In Reply Refer To:
HSST-1/B-40B

- Narrow QuickChange Moveable Barrier QMB modifications

Name of system:	Narrow QuickChange Moveable Barrier modifications
Type of system:	Portable / Moveable Longitudinal Barrier
Test Level	NCHRP Report 350 TL-3
Date of original request:	December 23, 2015
Original FHWA letter:	B-40 dated August 27, 1997
FHWA Control number:	B-40B

Oversized hole

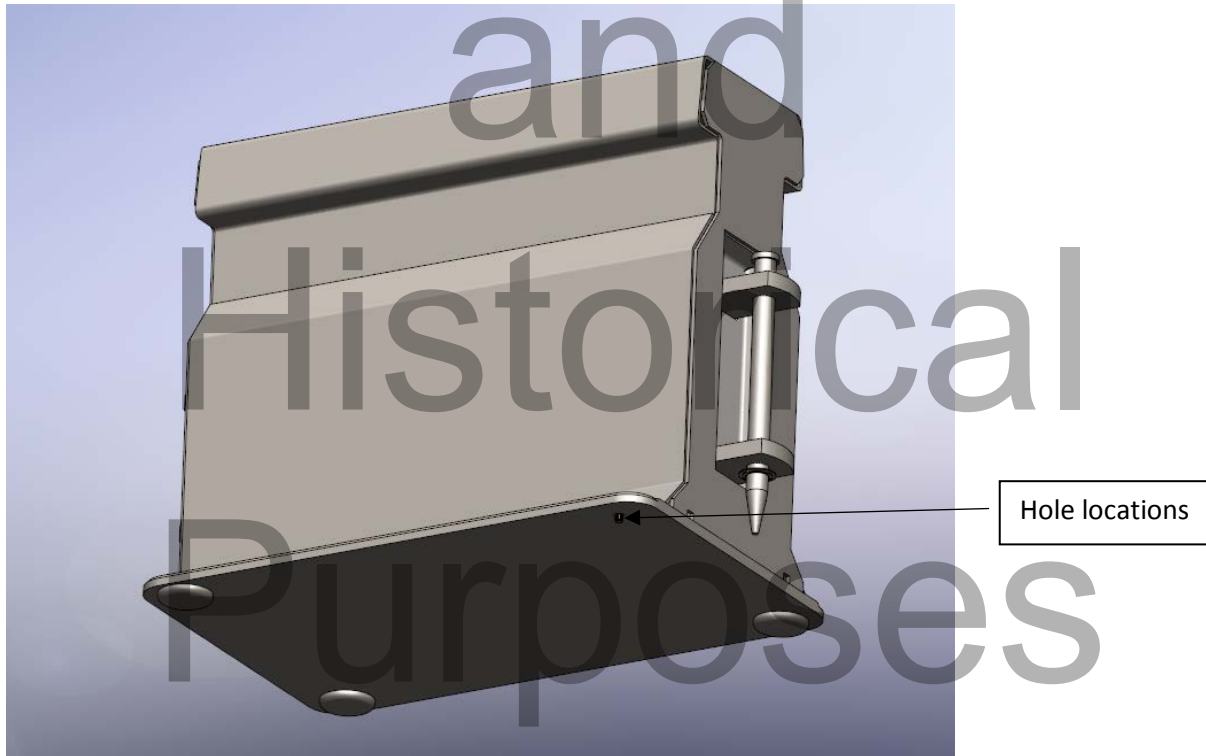
1) Each Narrow QMB barrier element is equipped with 4 rubber feet that are attached to the barrier through clearance holes at the four corners of the base-plates. The holes are slightly larger than what is required for the 1/2" bolts connecting the feet. As a result, there is the potential for the bolts to work themselves loose over time due to excess wiggle room. This request is for the acceptance of a slight reduction to the diameter of the clearance holes in the base-plates. This modification represents no change to the function, capacity or performance of the barrier element or the longitudinal barrier system as a whole.

New clip is shown on the left and the old clip on the right.

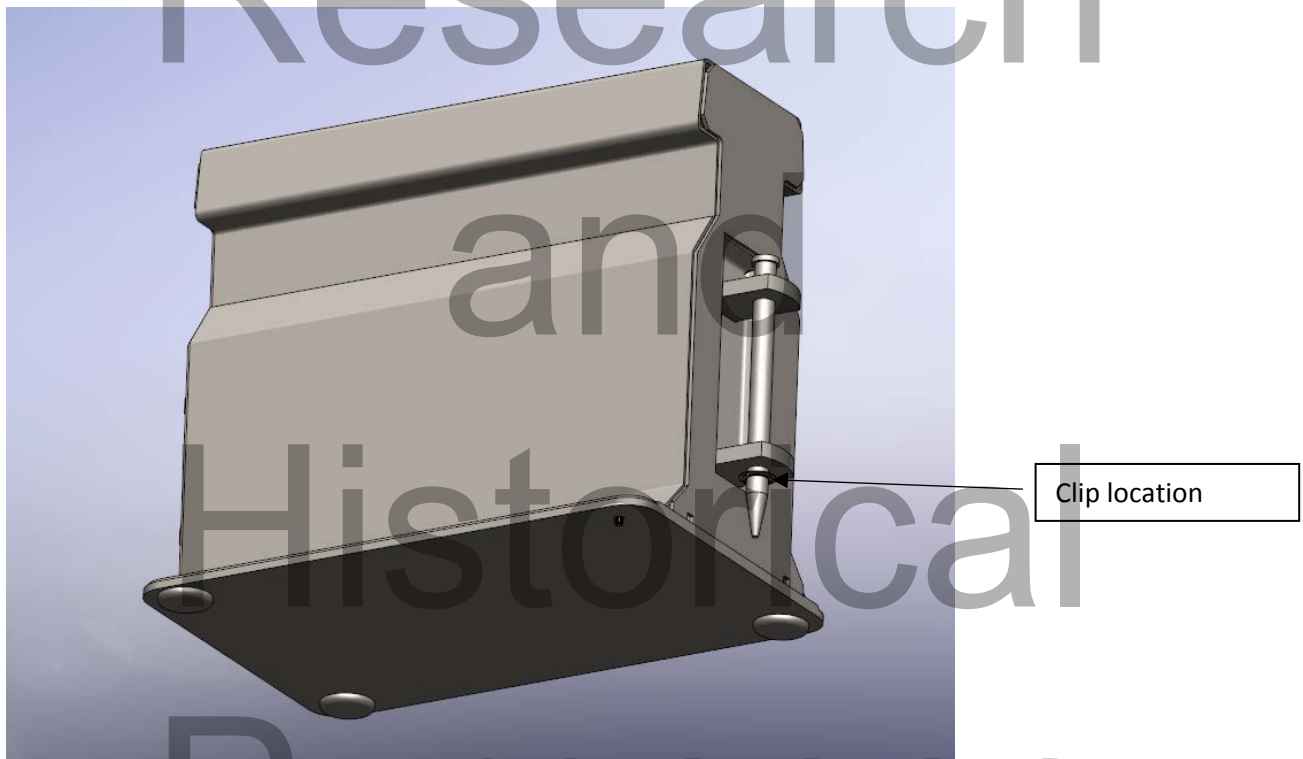
2) All Narrow QMB barrier elements are pinned together using a large 1-3/8" diameter pin. The pins have a small groove receiving a retaining clip that prevent the pins from working themselves out during the barrier transfer. Over the years a number of clips have fallen off. The failures are believed to be caused by fatigue. A stronger clip/washer configuration has been identified and proven to be up to 10 times more durable in bench testing. This request is for the acceptance of an alternative retaining clip. The clip does not come into play during crash testing, therefore this modification represents no change to the function, capacity or performance of the barrier element or the longitudinal barrier system as a whole.

New Pusher Plate on the left

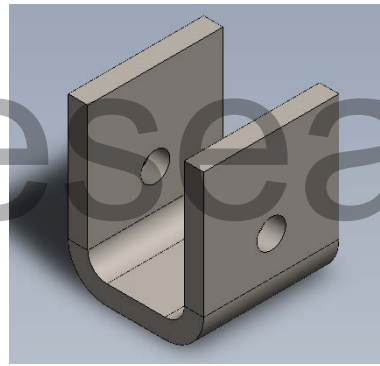
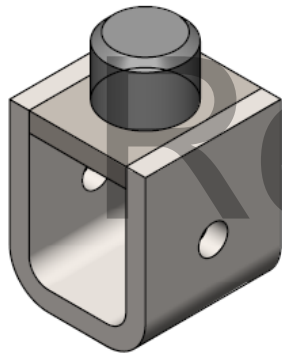
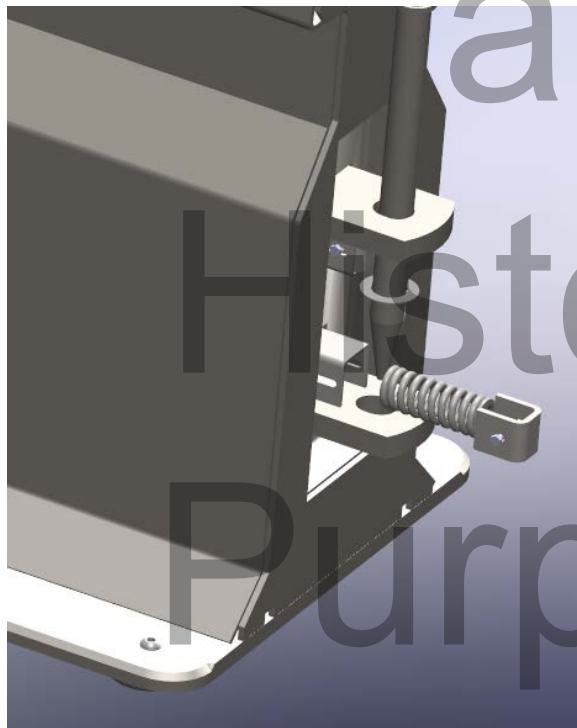
3) There are two springs at each joint where the pins connect the Narrow QMB barrier elements. These springs apply pressure on the pins connecting the barriers such that any slop in the hinges is removed and the barriers are always in tension (this is how the barrier gets its Reactive Tension designation). Having the barriers in tension helps reduce the deflection of the barrier wall during a crash. The springs sit in a mild steel housing and push against a "U" shaped plate that pushes against the pin. Over the years it was noticed that some springs have the potential of wearing a groove in the spring housing and occasionally get snagged in this groove such that they no longer apply pressure on the pin. A new "U" shaped plate was developed that has a small cylindrical rod welded to its ends. This rod keeps the spring centered in the spring housing preventing it from wearing out the spring. This new "pusher plate" can be used on new barriers going forward as well as to retrofit old barriers that were damaged by a wondering spring. The pusher plate is centrally located between the barriers and does not come into play during crash testing, therefore this modification represents no change to the function, capacity or performance of the barrier element or the longitudinal barrier system as a whole.

Old cap on the left.

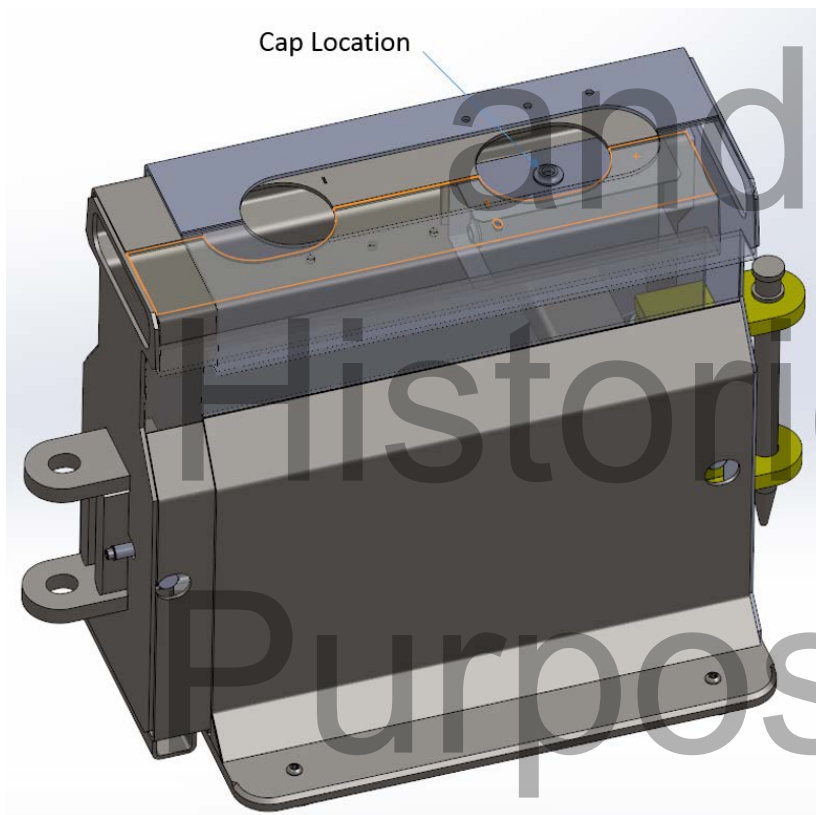
4) A key components of these longitudinal barriers is the Variable Length Barrier (VLB). The proposed modification involves the replacement of a cap internal to the VLB. The VLB has a hydraulic cylinder that is connected to a hydraulic reservoir. This reservoir has a small breather cap. The original caps were made of black plastic (ABS) and weigh approximately 1.1 ounces. Occasionally these caps got damaged and sometimes went missing. The new cap is a more durable steel cap that weighs roughly 1.3 ounces. The weight difference is negligible considering the overall weigh of a VLB is 800lbs. Therefore, this modification represents no change to the function, capacity or performance of the barrier element or the longitudinal barrier system as a whole.
